MANDATORY SERVICE BULLETIN No. M ATL-01a

PARACHUTES ATL-88/90, ATL-88/92-S INSPECTION OF THE NEEDLES OF THE RELEASE DEVICES

PROCEDURE OF PERFORMANCE OF CONTROL TESTS OF THE RELEASE U – 048/A

foto č. 1

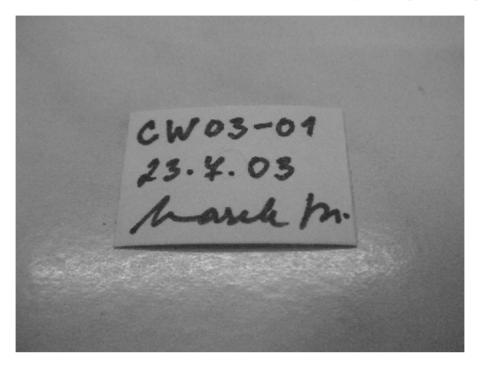
a) The handle of the release device must be marked CW 03-01, alternatively including date and signature.

4. We recommend the marking the handle with a self-adhesive plate with required inscriptions; if need be, the plate can be stuck all over with a transparent adhesive tape attached up to the area that has minimal resistance to abrasion and that is visible even when the release is hidden in a pocket. In emergency, the release can be marked with a permanent highlighter/marker.
